HYUNDAI Technical Service Bulletin

Group	ENGINE ELECTRICAL
Number	07-36-006
Date	SEPTEMBER, 2007
Model	SONATA, AZERA

Subject
CHECK ENGINE LIGHT P2138/P2127/P2122 DTC WITH P2106

(NON-ADJUSTABLE TYPE PEDAL)

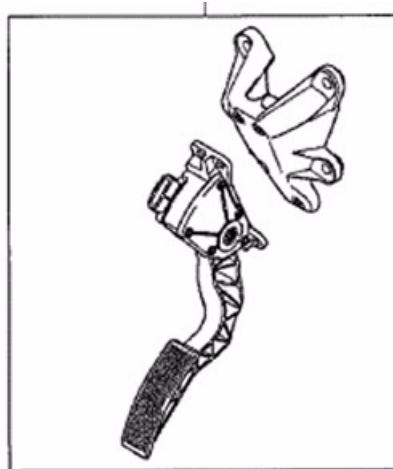
Replace the Accelerator Pedal Sensor Assembly.

NOTE: Do not replace ETC throttle body or PCM for the DTC P2106 as it is the result of the pedal sensor incident!

(ADJUSTABLE TYPE PEDAL)

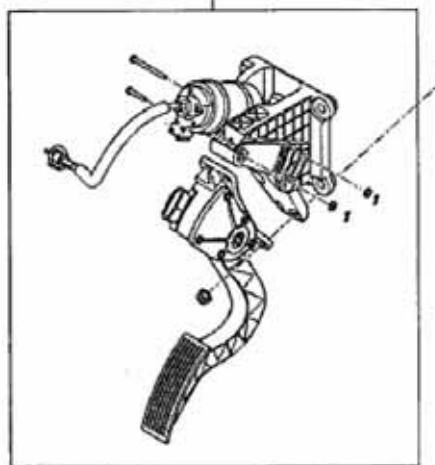
NOTE: For adjustable type pedal, only the pedal will be replaced; not with the bracket and adjuster motor.
